FILE P.I. # 621082-
Chattooga County
GDOT District 6 - Cartersville
Widening: SR 1 from CR 329 to North of CR 325 at SR 1/US 27

SUBJECT APPROVED REVISED CONCEPT REPORT

DEPARTMENT OF TRANSPORTATION
STATE OF GEORGIA
REVISED PROJECT CONCEPT REPORT

Raised concrete median replaces median barrier to provide adequate sight distance and roundabouts are proposed to improve intersection level of service issues.

REVISION DATES	STATE OF GEORGIA DEPARTMENT OF TRANSPORTATION
	OFFICE: ROADWAY DESIGN
	US27/SR1 SUMMERVILLE BYPASS TYPICAL SECTIONS
	DRAWING NO. 5-002

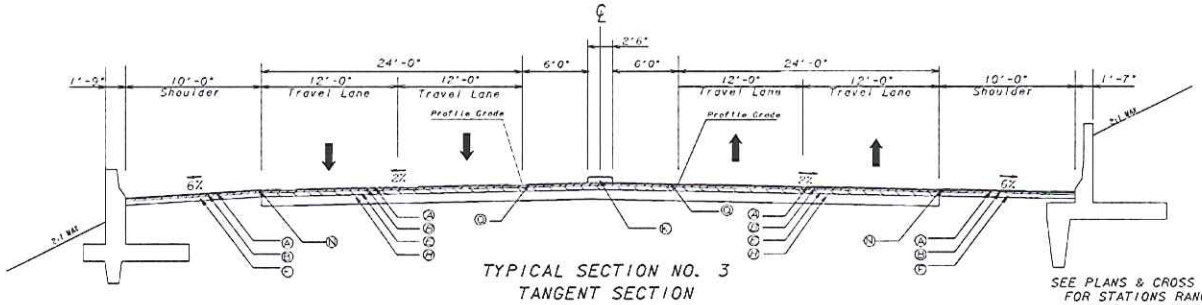
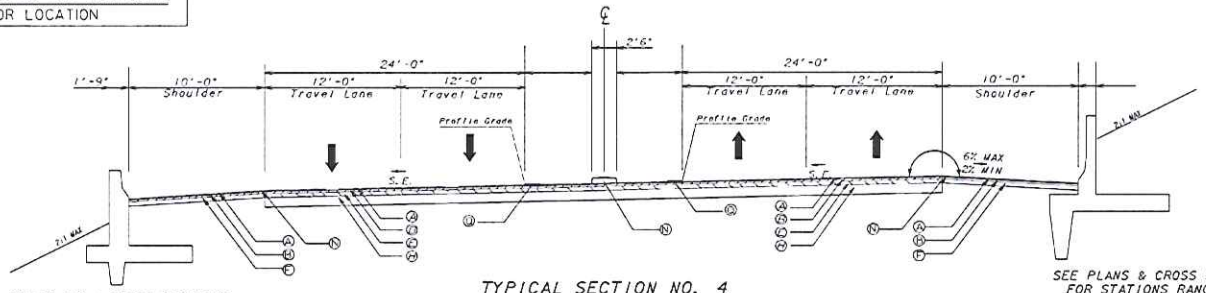
Approved Features:	**Proposed Features:**
1. Typical Sections • Two 12' lanes in each direction, 14.5' median with 2.5' wide – 2'8" (min) tall concrete barrier, and 10' outside shoulder from approximately a half mile north of CR329 Gore Subligna / John Jones Road to Mack White Gap. 2. Intersections • Two-way stop control at the proposed US27/SR1 tie-in points.	1.Typical Section • Two 12' lanes in each direction, 14.5' median with a 2.5' wide - 6" tall raised concrete median, 10' outside shoulder and side barrier from approximately a half mile north of CR329 Gore Subligna / John Jones Road to Mack White Gap. 2. Intersections • Roundabouts are proposed at the US27/SR1 tie-in points.
Reasons for change: 1. The typical section from a half mile north of CR329 Gore Subligna / John Jones Road to Mack White Gap was revised from barrier to raised median to provide adequate sight distance. 2. The proposed traffic volumes at both tie-ins did not warrant a signal and two way stop control did not provide a satisfactory LOS.

DRAWING NO. 13-10

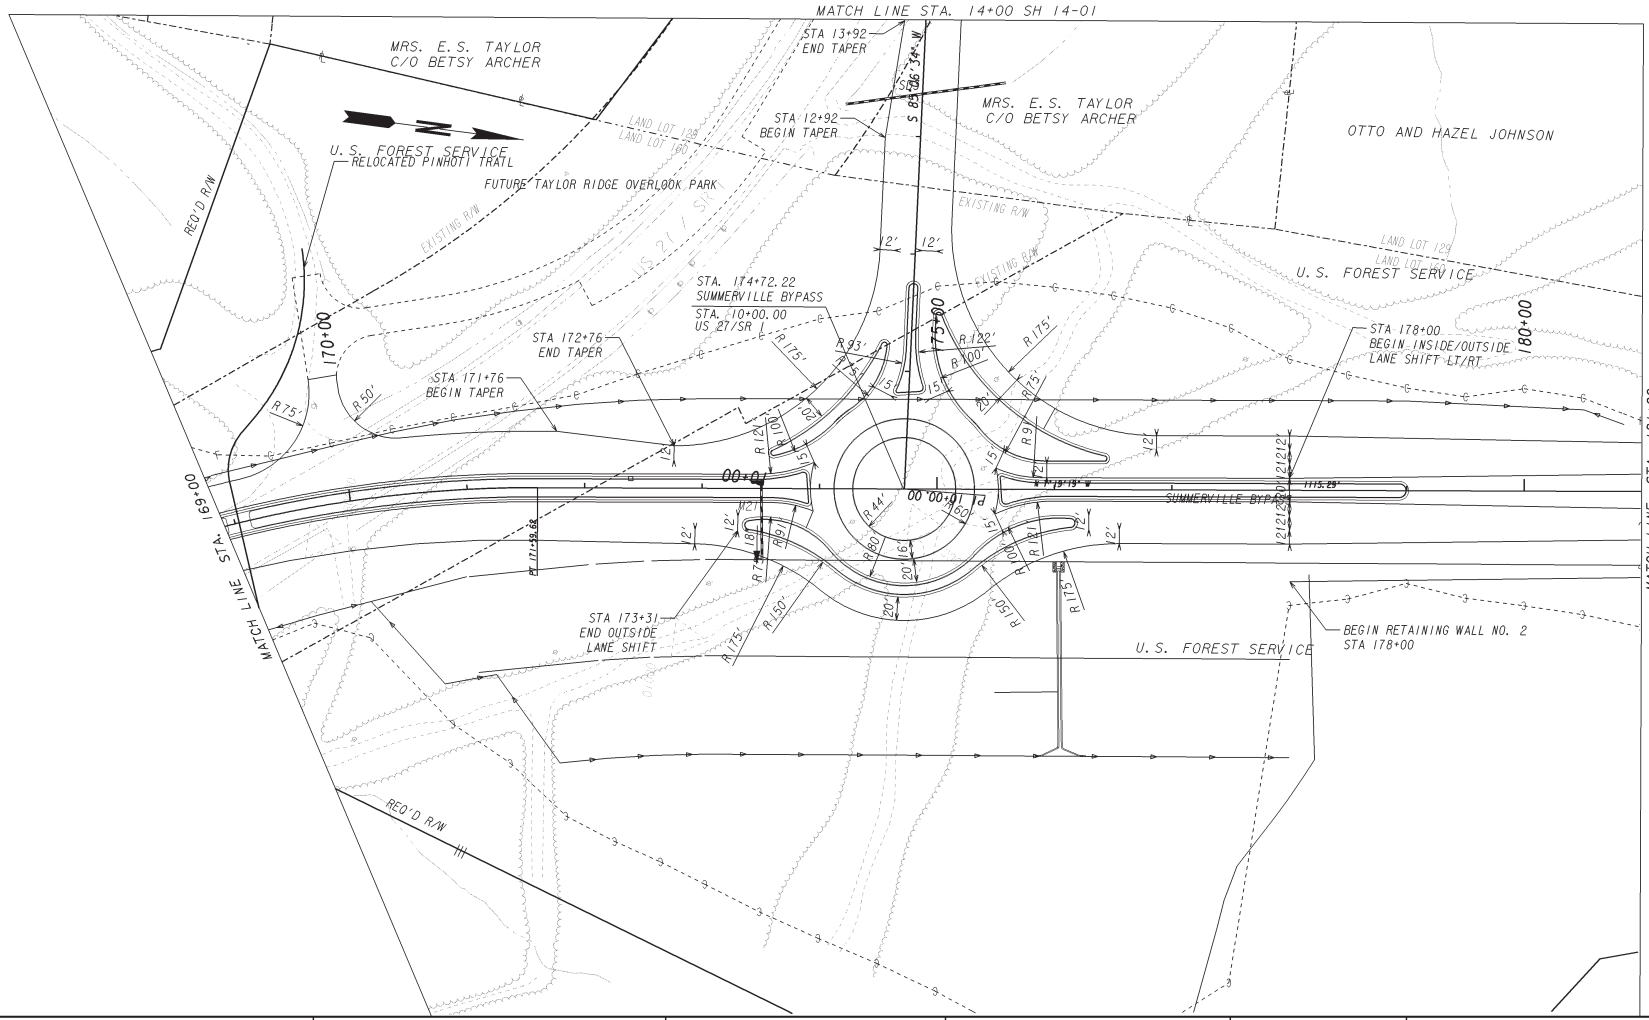
Kittelson & Associates, Inc. (KAI) has reviewed the conceptual roundabout design and supporting documentation for the roundabout proposed near the southern end of the Summerville Bypass at SR 1-US 27 near Summerville in Chattooga County, Georgia. KAI identified potential capacity concerns with the use of a single-lane roundabout for the 2035 design year. We believe the roundabout should be modified to provide two through lanes consistent with the basic number of lanes on the Summerville Bypass. In addition, design modifications are needed to better accommodate WB-67 design vehicles for all movements through the roundabout.

The operations analysis prepared by the Georgia Department of Transportation (GDOT) was reviewed to verify whether the lane configurations will provide acceptable design-year traffic operations. Given that the Summerville Bypass will be constructed as a four-lane roadway, KAI recommends that GDOT consider modifying the roundabout to be designed as a multilane configuration in the opening year to provide two through lanes north-south through the roundabout. This configuration promotes basic lane continuity along the Summerville Bypass and helps to increase the entry capacity along the northbound and southbound approaches.

Based upon KAI's review of the GDOT operations analysis, it also appears that a single-lane entry on the southbound approach will operate with a v/c ratio greater than 1.0 during the 2035 p.m. peak hour based upon the NCHRP Report 572 capacity methodology. This further supports the use of a multilane configuration with two entering and exiting lanes along the Summerville Bypass. The eastbound SR 1-US 27 approach would have one roundabout entry and exit lane for opening year, with the design allowing for the future addition of a yield controlled right-turn bypass lane to handle the heavy projected right-turn demand. Conceptual sketch illustrations of a multilane roundabout design (with and without an eastbound bypass lane) are provided in Figures 1 and 2 respectively.

DRAWING NO. 13-33

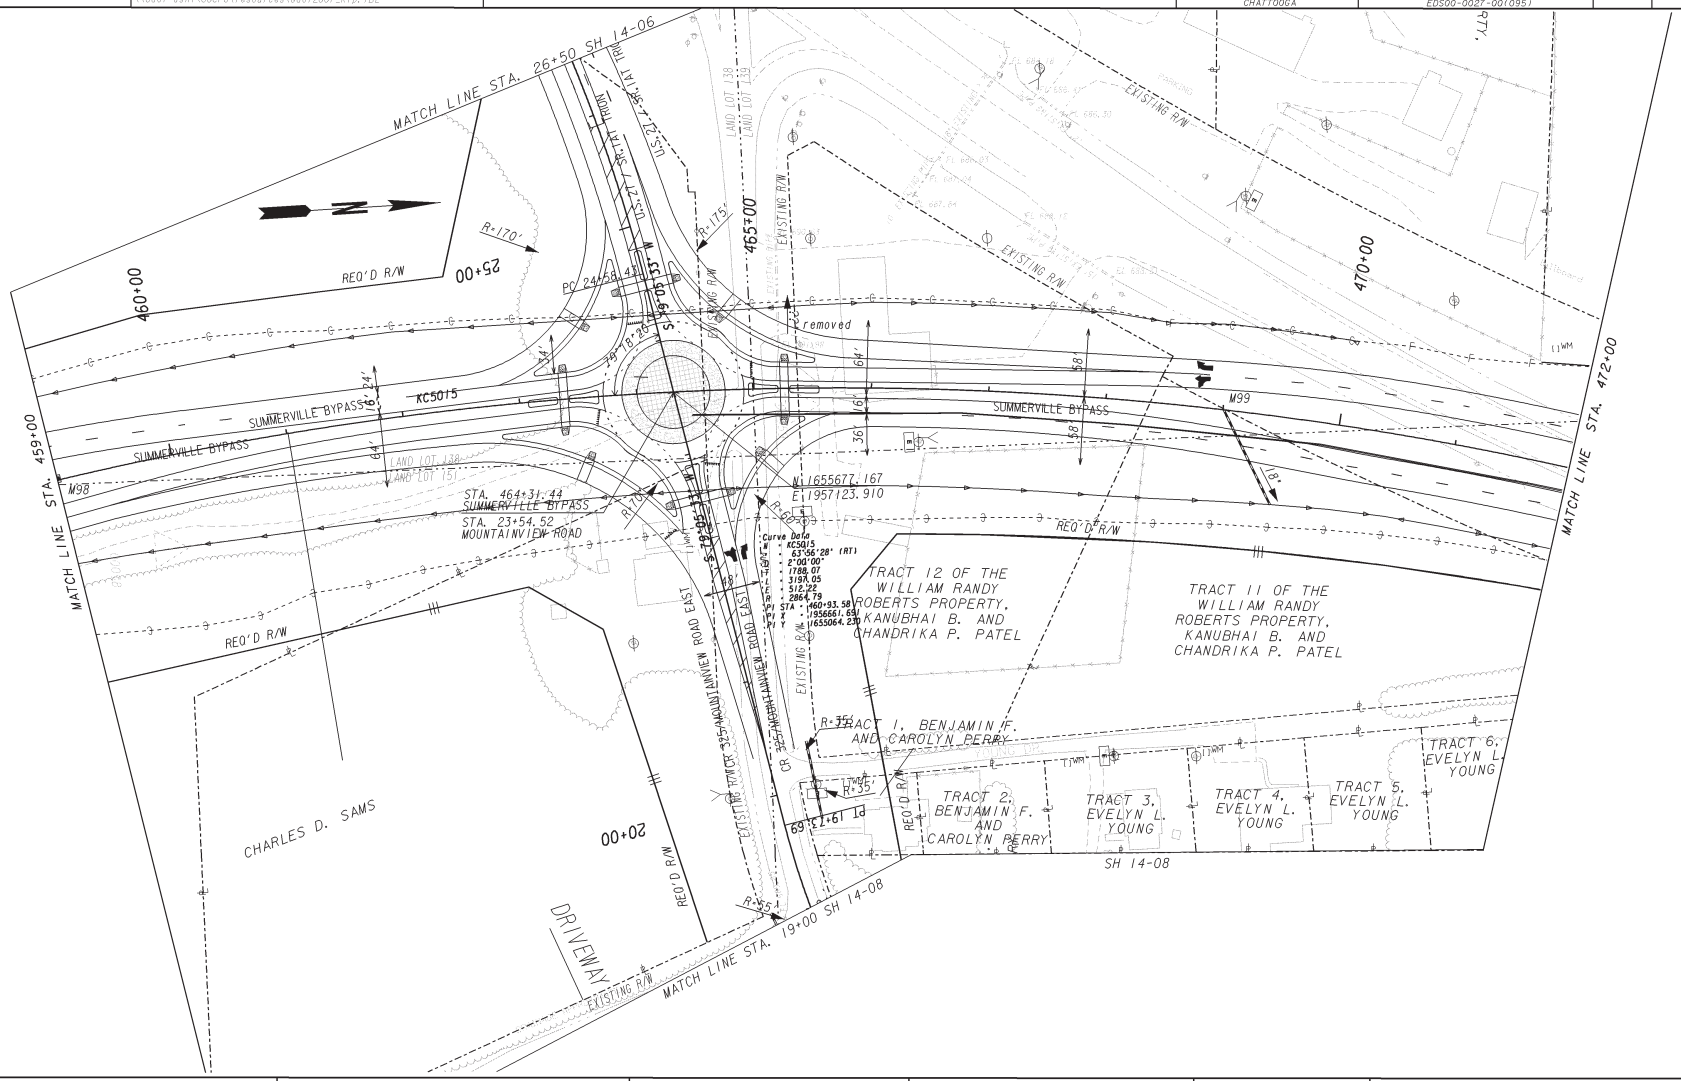
Kittelson & Associates, Inc. (KAI) has reviewed the conceptual roundabout design and supporting documentation for the roundabout proposed at the northern terminus of the Summerville Bypass at SR 1-US 27 near Summerville in Chattooga County. KAI identified several areas of the design that we believe to be undesirable and should be given further consideration. These include a lack of capacity for the 2035 design year and undersized roundabout design given the suburban/rural environment. We believe the roundabout should be modified to provide two through lanes consistent with the basic number of lanes on Summerville Bypass. In addition, the design should be modified to include speed management elements to support speed reduction from 65 mph to 25 mph. The following sections summarize our observations in more detail.

The operations analysis prepared by the Georgia Department of Transportation (GDOT) was reviewed to verify whether the lane configurations will provide acceptable design-year traffic operations. The KAI review identified several errors in the input of the traffic volumes into the GDOT analysis spreadsheet. In the a.m. peak hour analysis, the p.m. volumes were mistakenly used for some movements including the EB through and SB left. In the p.m. peak hour analysis, incorrect values were used for the southbound left, westbound through, northbound left, and eastbound through movements. In addition, no analysis was performed on the yield-controlled northbound to eastbound bypass lane.

KAI updated the analysis with the correct volumes and identified that a single-lane roundabout with right-turn bypass lanes is forecast to operate over capacity on the northbound and eastbound approaches (south and west legs) during the 2035 design year. Based upon the NCHRP Report 572 capacity methodology, the northbound approach is estimated to have a volume-to-capacity (v/c) ratio of 1.4 during the weekday a.m. peak hour and near 1.00 in the weekday p.m. peak. The eastbound approach is also estimated to have a v/c near 1.0 in the weekday a.m. and p.m. peak hours.
